RISBRIDGER PART NO. 2467-MK2 SHUT OFF VALVE ASSEMBLY

INSTRUCTION SHEET: 2467-MK2

2467-MK2 Exploded Assembly Drawing

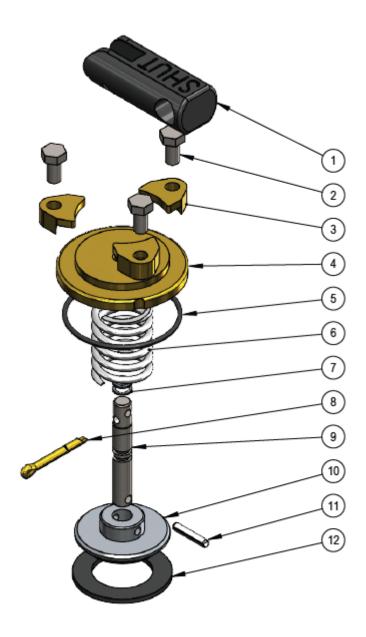
The existing **2467** assembly has now been replaced with the **2467-MK2** assembly. The **2467** assembly was supplied with a pressed brass cap which is now no longer available. The cost for Risbridger to find a new supplier of these, and the cost of all new tooling was determined to be too prohibitive. The new design of the **2467-MK2** comes with a fully machined brass cap, with changes necessary to reduce the cost impact to our valued customers.

Amendments to fitting procedure for 2467-MK2 assembly:

- Ensure the valve is in an 'open' position before fitting to the check valve body. This ensures easier installation. The engraved 'OPEN' text on the black lever should face uppermost
- Fit the **2467-MK2** assembly to the Angle Check Valve body and rotate it so that the three half moon indentations on the outer circumference are aligned to the hole locations
- Loosely fit the three locating lugs and hex bolts. Sequentially tighten the bolts to ensure that the cap is seated flush and that the cap O-ring is evenly compressed
